Intel[®] Celeron[®] Processor Specification Update

Release Date: August 2007

Document Number: 243748-051

Figure 1 Celeron® on 0.13 Micron Processor 256K Platforms Workaround

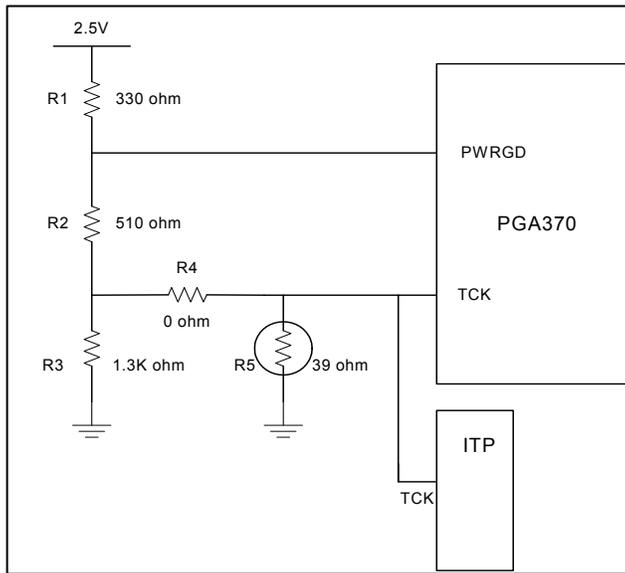
Workaround: To prevent the risk of power-on boot failures or catastrophic thermal failures, a platform workaround is required. The system must provide a rising edge on the TCK signal during the power-on sequence that meets all of the following requirements:

Please note, the example workaround circuits attached require circuit modification for ITP tools to function correctly. These modifications must remove the workaround circuitry from the platform and may cause systems to fail to boot. Review the accompanying notes with each workaround for ITP modification details. If the system fails to boot when using ITP, issuing the ITP 'Reset Target' command on failing systems will reset the system and provide a sufficient rising edge on the TCK pin to ensure proper system boot.

In addition, the example workaround circuits shown do not support production motherboard test methodologies that require the use of the processor JTAG/TAP port. Alternative workaround solutions must be found if such test capability is required.
